Dowses Beach and Bathhouse

ADA Transition Plan

October 2021

Institute for Human Centered Design

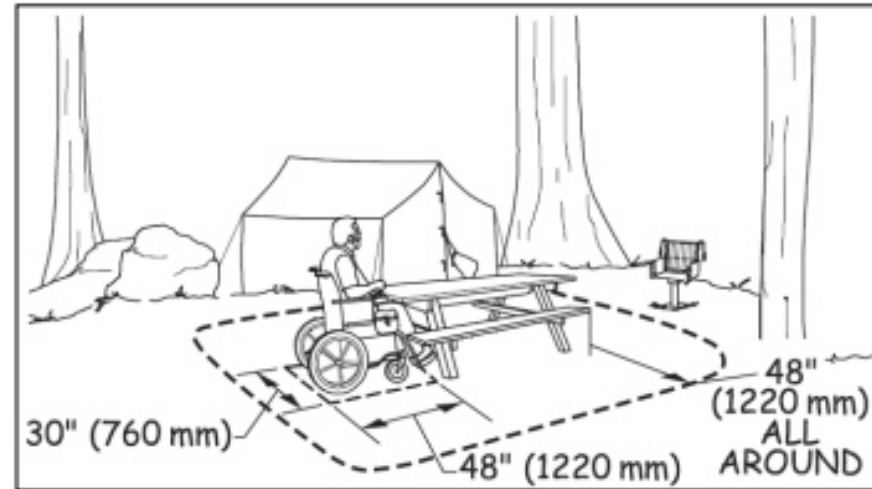
Note: See Figure 1 on Page 2 of this report showing the suggested location for additional beach access routes that could be created with the use of beach mats.

There is a lack of a stable and firm beach access route to at least one of the available beach umbrellas, a wooden beach access route accessed by a walkway that joins the wooden route at the rinsing shower does not extend all the way to the high tide level, and there is lack of a stable and firm beach access route at Access Point #5 and at Access Point #9 extending to the accessibility monument, the beach area below the viewing platform and the high tide level.

- Recommend extending beach access route to at least one lifeguard station so a visitor with a mobility disability could navigate to a lifeguard station should the need arise.
- Recommend using beach mat material to create accessible sitting areas that extend for beach access routes and are located near the high tide level.
- When an accessible picnic table is provided on an accessible route, IHCD recommends providing a stable, firm and slip-resistant surface for 48" clear on all sides of the picnic table. See the following illustration:
